# CITY OF OAKLAND

## Memorandum

**Re:** 10-10<sup>th</sup> St. Case File PLN17101. Proposed Rehabilitation and Alterations of the Oakland Civic Auditorium

**STAFF REPORT**

2 NORTH ELEVATION - PROPOSED  
1" = 30'-0"

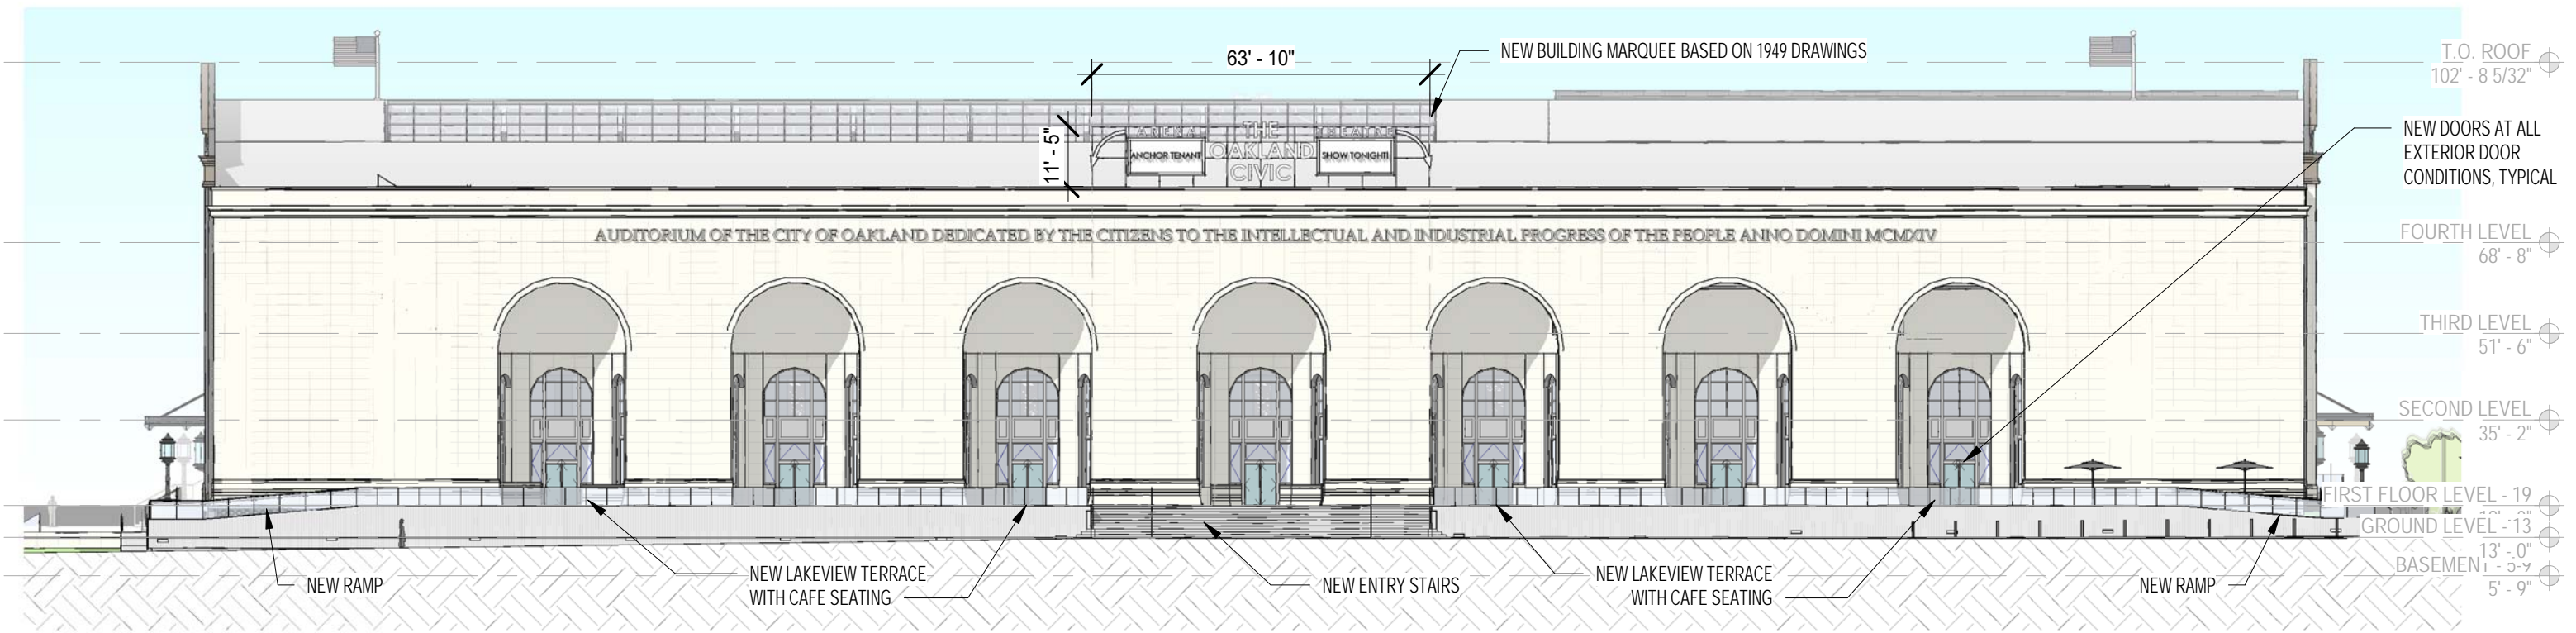
- The design of the raised terrace may block the view of the niches;
- Design the raised terrace so that is easily removable from the main building;
- The facade of the raised terrace need to have similar materials, color and texture;
- Include high quality landscaping in front of the raised terrace, but don't block the facade entirely;
- The entry and pathway from Lake Merritt Boulevard through the parking lot and to the building needs more development to create a better pedestrian connection;
- Clarify the pedestrian pathway circulation around the property, and include details;
- Provide better color renderings of the building, raised terrace and entry pathway from the street.

The Oakland Civic Auditorium is considered a City Landmark because of its significant historical, architectural and cultural value. The proposal would replace the north concrete entries of the OCA with a raised terrace that extends approximately 400 feet along façade of the building. The seven-foot tall concrete terrace with a three and one-half foot tall glass guardrail would potentially visually obstruct the lower area of the prominent arched niches and entry stairs when viewed from Lake Merritt Boulevard and the Lake Merritt shore. Staff believes that the proposal would create an unnecessary impairment of the physical features that contribute to highest level of recognition of historic significance for the OCA..

Staff would support a plan for a larger terrace in front of the OCA if it is built at grade. The applicant may consider building a forecourt between the building and the parking lot. The forecourt would include a wider entry pathway that connects OCA from Lake Merritt Boulevard. The forecourt and pedestrian pathway could include distinctive paving materials, landscape barriers or planters, outdoor furniture, and bollard lights to create a separation from the parking lot.

- Replace the raised terrace with one that is at grade level.
- Place the new terrace access ramps at the ends of the front building.
- Provide a simple and subtle design to the surface parking.
- Make the pathway entry in the parking lot more prominent.
- Clarify the pathway from the promenade to Lake Merritt Boulevard.
